Residential apartment, Tower-final QA and handover snag list

Project:	Residential apartment, Tower-final QA and handover snag list	Client Name:	Emily Rodriguez
Job Reference:	US-F033-NYC	Company Name:	Skyline real estate holdings
Start Date:	06/15/2025	Auditor Name:	Jason Patel
Location:	845 8th Avenue, New York NY 10019, USA	Auditor Company Name:	Urban QA services LLC
Total Snags:	10

Wardrobe Handle Loose and Wobbling

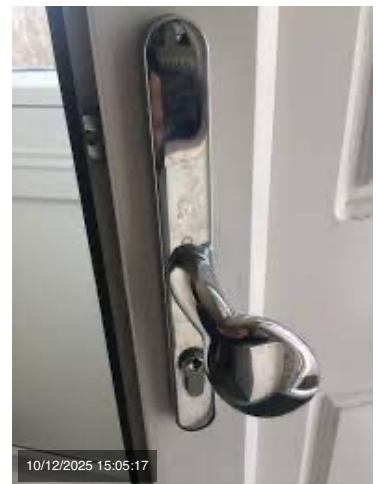
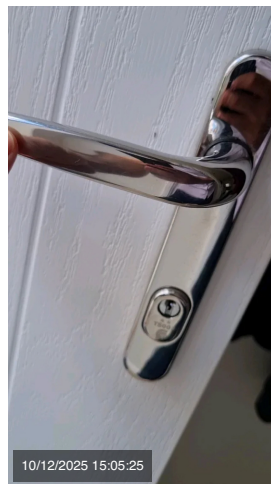
The metal handle on wardrobe door is loose, causing improper grip. Tighten screws or replace hardware to match existing finish.

Ceiling Patch Marks Visible After Repair

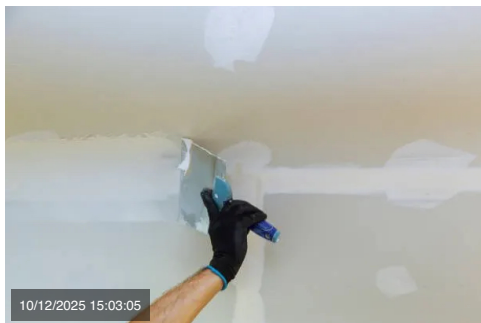
The false ceiling shows patchy texture where repair work was carried out. Needs surface sanding and uniform repainting for a smooth finish.
